**Analysis of Public Comments on Draft Regulatory Issue Summary 2015-02,
“Reporting of H-3, C-14, Tc-99, and I-129 on the Uniform Waste Manifest”**

A notice of opportunity for public comment on the Draft Regulatory Issue Summary (RIS) 2015-02, “Reporting of H-3, C-14, Tc-99, and I-129 on the Uniform Waste Manifest” was published on June 2, 2014 in the *Federal Register* (79 FR 31348) with a 30-day comment period ending on July 2, 2014. Below is the list of entities that commented on the draft RIS, as well as the Agencywide Documents Access and Management System (ADAMS) accession numbers for their comments. To access ADAMS, go to <http://www.nrc.gov/reading-rm/adams.html>.

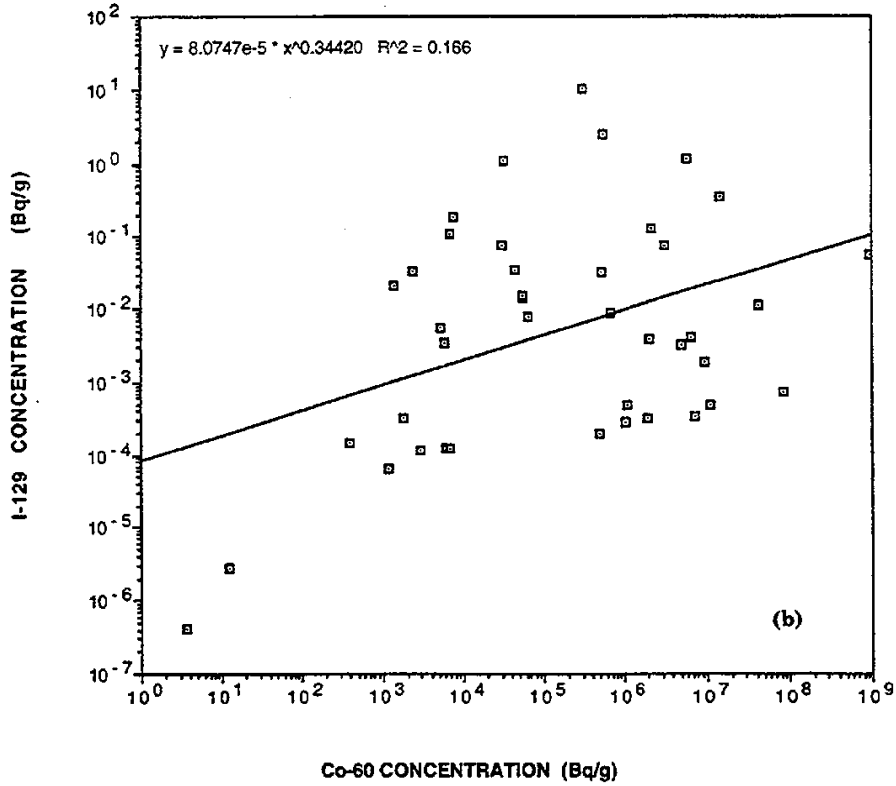
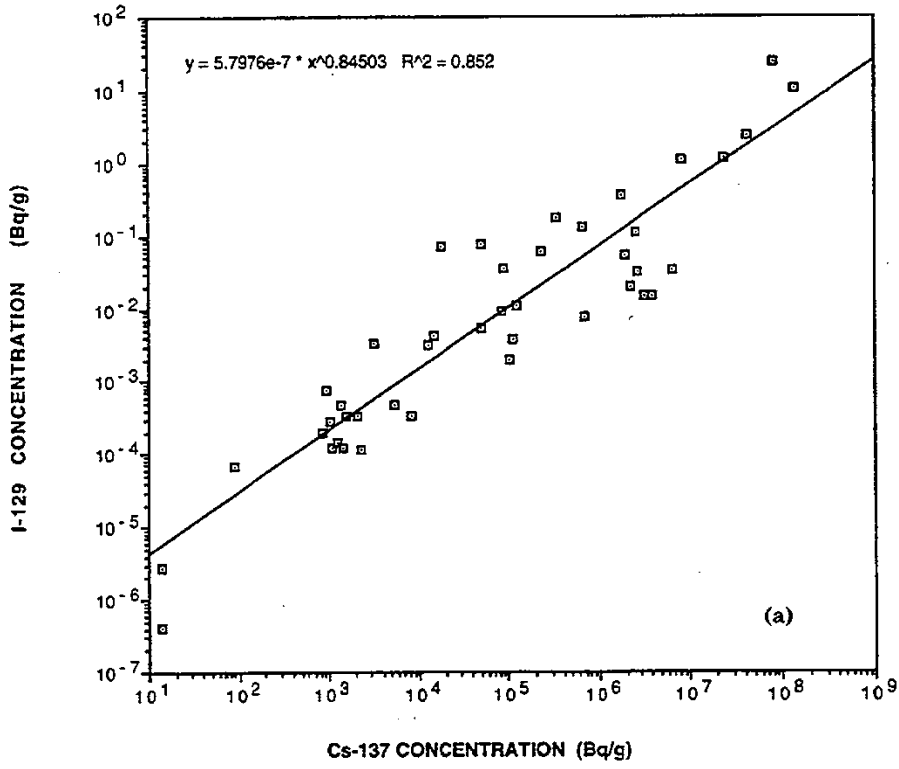
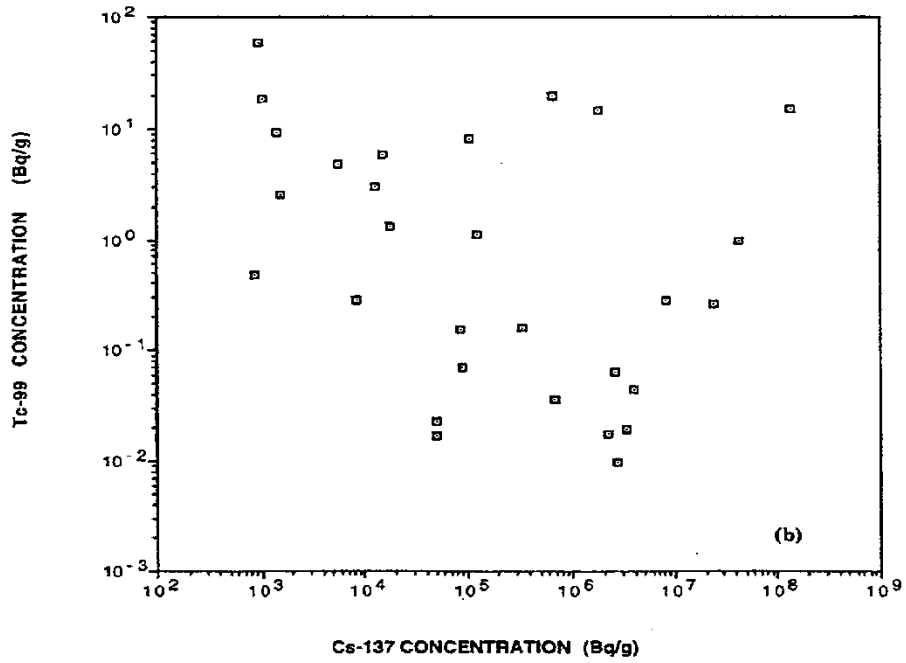
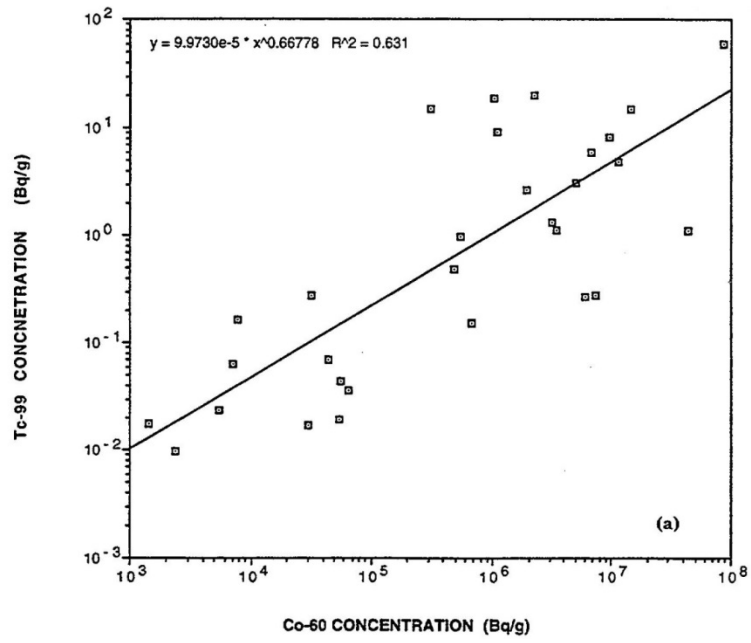
The other two commenters suggested that the RIS should be edited to specifically allow for the use of scaling factors developed by EPRI based on samples analyzed using mass spectrometry (MS). These commenters indicated that the industry scaling factors had been derived using the dispersion method, and both suggested that this was the appropriate statistical method for evaluating a data set with a large variation. Additionally, the commenters noted that the use of generic scaling factors should be evaluated for change when a large fuel defect is present.

The MS analyses performed by PNNL referred to in these comments are documented in NUREG/CR-6567. In the research documented in this report, a variety of low level waste samples were obtained from commercial nuclear power reactors. The activities of Tc-99 and I-129 in these samples were measured using the highly sensitive MS methods. The sample results are listed in Table 7.8 of NUREG/CR-6567 and include 45 samples from both BWR and PWR plants. The types of waste sampled include resin, dry active waste, filters, charcoal, soil, lubricating oil, and reactor coolant. As is shown in Table 7.8, the ratios of I-129 and Tc-99 to Co-60 and Cs-137 were calculated for each sample. Geometric means of these ratios were also calculated for each radionuclide pair. Scatter plots of the concentrations of I-129 and Tc-99 versus Co-60 and Cs-137 from NUREG/CR-6567 are reproduced below.

The figures above revealed a degree of I-129 and Cs-137 correlation and a degree of Tc-99 and Co-60 correlation, but correlations between I-129/Co-60 and Tc-99/Cs-137 were not observed. The lack of correlation may be due to differences in the production mechanism of these radionuclides (i.e., I-129 and Cs-137 are fission products while Co-60 is an activation product and Tc-99 is both a fission and an activation product). The NRC staff believes that the lack of correlation may also be due to the fact that many waste types and plant types are included in this data set. A better correlation may be seen for data sets that include similar waste streams from similar plant types. The research in NUREG/CR-6567 is therefore not adequate on its own to support a generic scaling factor. More research is needed to understand the correlations between these radionuclides in different waste streams and the range of conditions under which the correlations are applicable. Additionally, this study only included 45 samples that were taken between 1988 and 1996; more sample data, including more recent samples, are needed to supplement the research in the NUREG/CR.

NRC staff has not seen information that demonstrates that these correlations are improved when a particular statistical method is used. If such information exists, any person may voluntarily submit this information to the NRC for its review.
